**No. AS350-05.01.03**

# ALERT SERVICE BULLETIN

Check for absence of rotation of the bearing spacer of the Tail-Rotor-Head (TRH) pitch-change-unit  
 ATA: 65

Revision No.	Date of issue
Revision 0	2021-12-16
Revision 1	2024-07-08

Figure 1

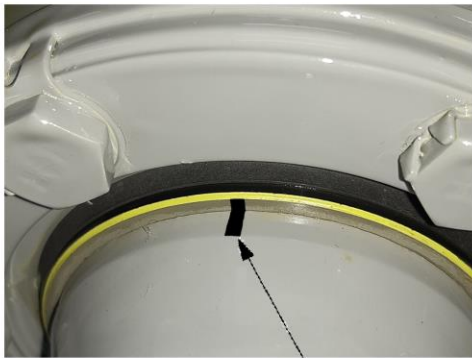
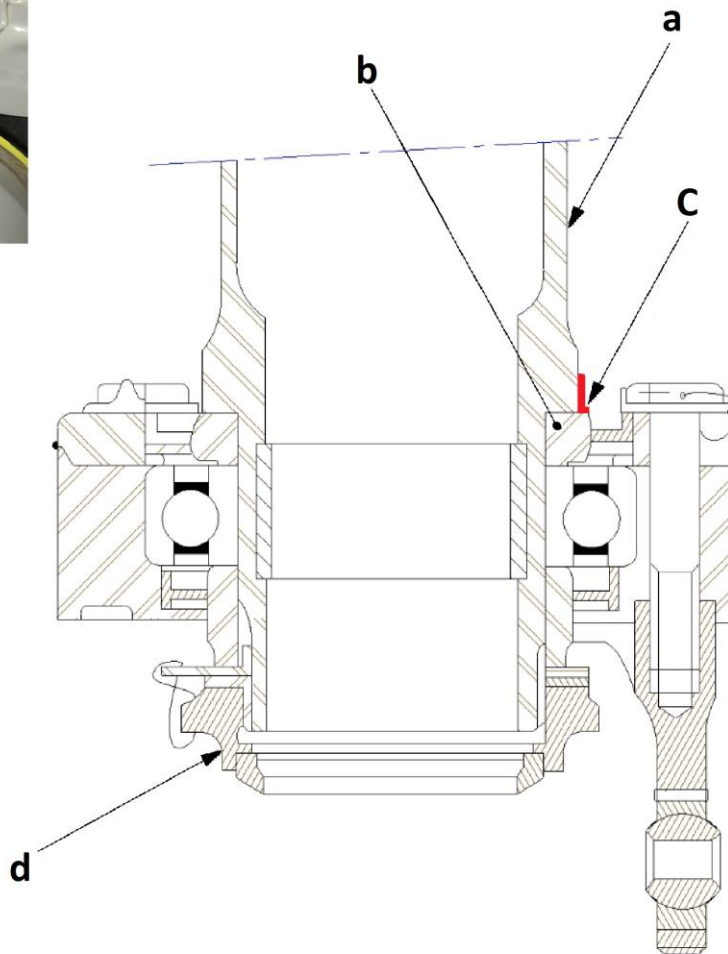
##### 3.B.2.a. Check of the presence of the nut and its good installation and application of black paint index mark ([Figure 1](#))

Make sure that the nut (d) is not missing and well installed (not loose):

- If the nut is missing or loose:
  - . Inform the Airbus Helicopters Support Department about the results by a creation of a Technical Event (TE) on WebTEK: <https://airbusworld.helicopters.airbus.com>
  - . Comply with paragraph [3.B.2.c.](#)
- If the nut is not missing and not loose:
  - . Identify the position of the TRH pitch change unit (a) and of the bearing spacer (b) by means of a 2 to 5 mm wide black paint index mark (C) with the black paint (2) (not shown).  
Then:
    - . Record the MOD 0765002 in the Log Card (FM) of the TRH pitch change unit. Refer to paragraph [3.C.](#)

#### 3.B.2.b. Monitoring of black paint index mark ([Figure 1](#))

#### 3.B.2.c. Inspection of the TRH pitch change unit ([Figure 1](#))

- Make sure that there is no damage on the rotating plate (not shown) and on the rotating plate threads with the magnifying lens (zz).
  - . If there is damage, replace the rotating plate (not shown).
  - . If there is no damage, install again the rotating plate (not shown).
- Comply with paragraph [3.B.2.a.](#)
